COUNCIL ASSESSMENT REPORT

Panel Reference	2015SYE087
DA Number	DA2015/0597
LGA	Northern Beaches Council
Proposed Development	Demolition works, alterations and additions to existing buildings, construction of new school buildings and an increase in student numbers at Manly Vale Public School
Street Address	Lot 1768 Sunshine Street, Manly Vale
Applicant/Owner	<p><u>At lodgement</u></p> <p>Owner: Department of Education Applicant: Department of Public Works</p> <p><u>From 14 June 2016</u></p> <p>Owner: Department of Education Applicant: Department of Education</p>
Date of DA lodgement	30 June 2015
Number of Submissions	<p><u>Public Exhibition No. 1</u> (17/7/2015 to 18/8/2015)</p> <p>160 submissions received consisting:</p> <ul style="list-style-type: none"> • 129 (80.6%) against. • 31 (19.5%) in support. <p><u>Public Exhibition No. 2</u> (7 /10/2016 to 25/10/2016)</p> <p>160 submissions received consisting:</p> <ul style="list-style-type: none"> • 91 (56.9%) against. • 69 (43.1%) in support. <p>1 petition against with 14 signatures against the proposal.</p> <p><u>Public Exhibition No. 3</u> (12/11/2016 to 13/12/2016)</p> <p>14 submissions received as at 5 December 2016 consisting:</

Figure 7: Design layout of the development as presented to Council at the pre-lodgement meeting.

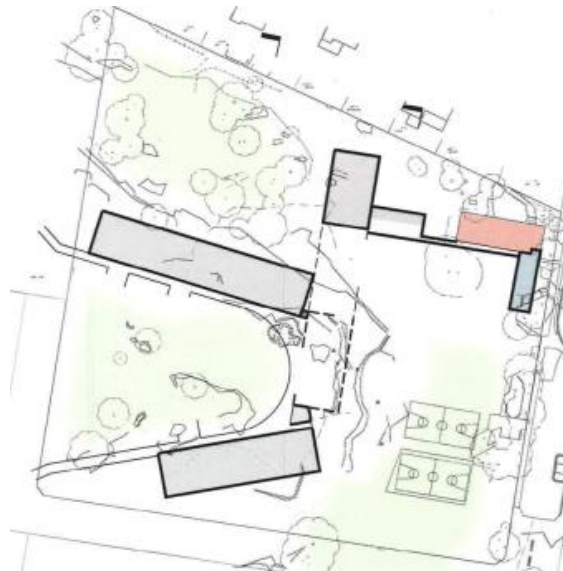
The Pre-lodgement Notes concluded that the proposal was considered to be inconsistent with the following clauses in the Warringah Development Control Plan 2011:

“Insufficient detail was provided at the meeting with respect to the number of staff in attendance at any one time to ascertain the number of parking spaces required. However, concern was raised regarding the on-going reliance upon the public car park located within Gibbs Street.

Figure 8: Original Site layout and Building Reference.

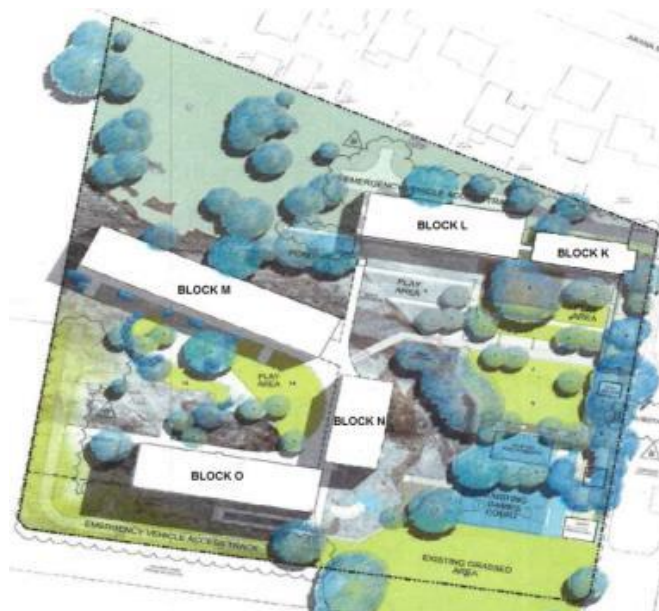
Block L is a part elevated single storey building located to the west of Block K and will provide for a hall, canteen sports store, toilets, staff room etc.

Revised plans submitted to Council on 18 April 2016 includes the provision of an on-site parking area for 11 vehicles within the undercroft area of Block L. The carpark is accessed from Sunshine Street via a 3.0m wide driveway.

Figure 10: Retained vegetation islands (original scheme)

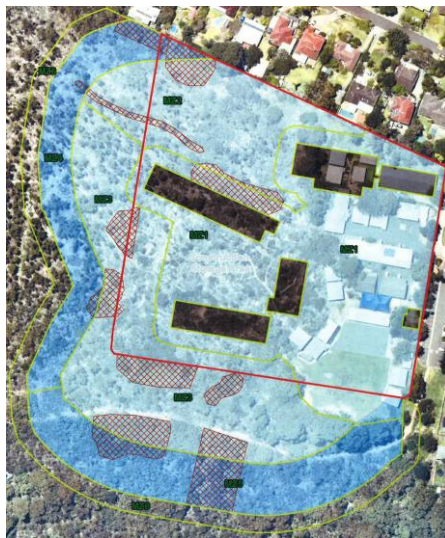
The revised Landscape Management Plan also states that 0.56ha (5,600m²) of the total APZ area will be retained as vegetation islands and cultural heritage exclusion zones.

Figure 11: Location of threatened species within the site and APZ area (applicable to both the original and amended scheme)

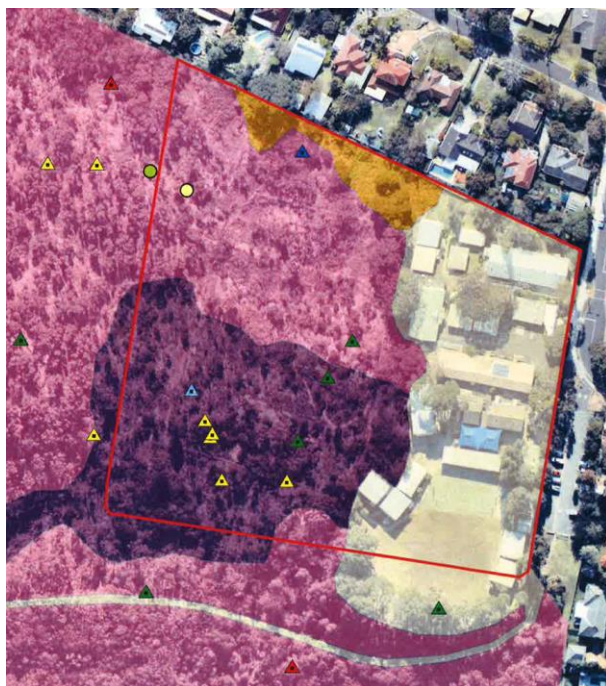
Figure 11 below shows the location of identified threatened species within the site and within the APZ areas. The species are:

"All clearing activities surrounding identified cultural heritage sites must be supervised by a suitably qualified and experienced Project Ecologist engaged by the Project Manager, to ensure areas of cultural significance (see Figure 11 in this report) are protected.

Figure 15: Retained vegetation islands.

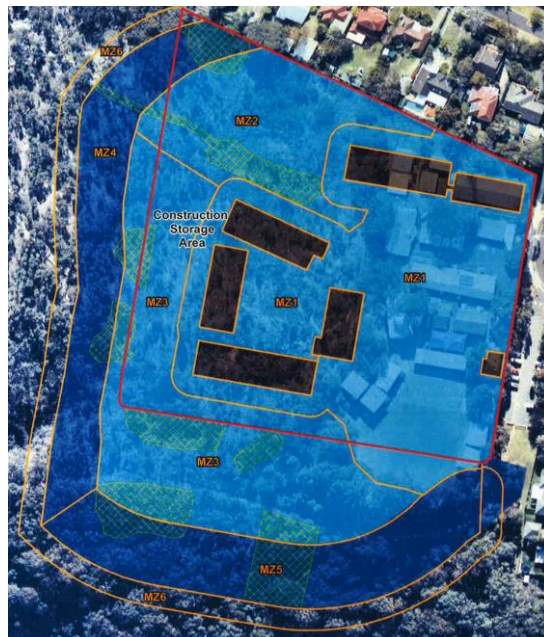
The revised Landscape Management Plan also indicates that 20% of the total APZ area (including the area of the subject site) will be retained as vegetation islands and cultural heritage exclusion zones. Given that the total APZ is approximately 47,446m² (i.e. 28,500m² + 18,946m²), the area allocated for the retained vegetation islands will equate to approximately 9,489m².

The above indicates that the physical area of the APZ (37,956m² (or 3.79 ha) being 28,500m² + 18,946m² - 9,489m²) will be 1,456m² more than the estimated area of 36,500m² (or 3.65 ha) identified for selective removal and modification in the revised Landscape Management Plan (v.5.0). However, the two should not be confused as they represent different aspects of the APZ and it is accepted that the physical area of the APZ would be

Figure 16: Nominated areas of compulsory acquisition to accommodate APZ areas.

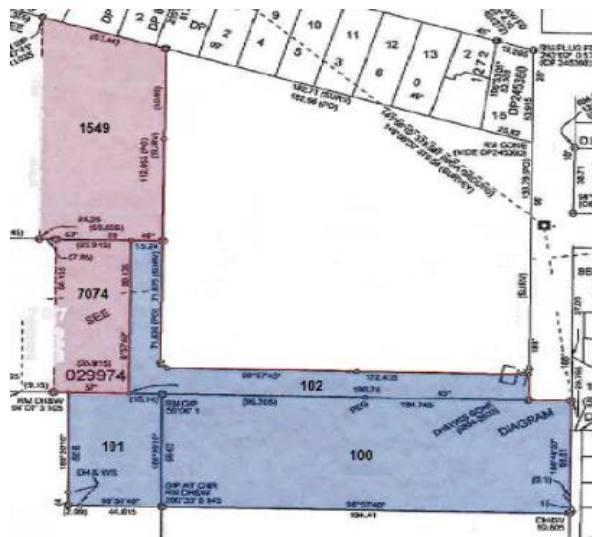
It is noted that the areas of acquisition indicated in Figure 12 above are larger than the actual APZ areas and do not, therefore, indicate the area of vegetation clearing required for the APZ.
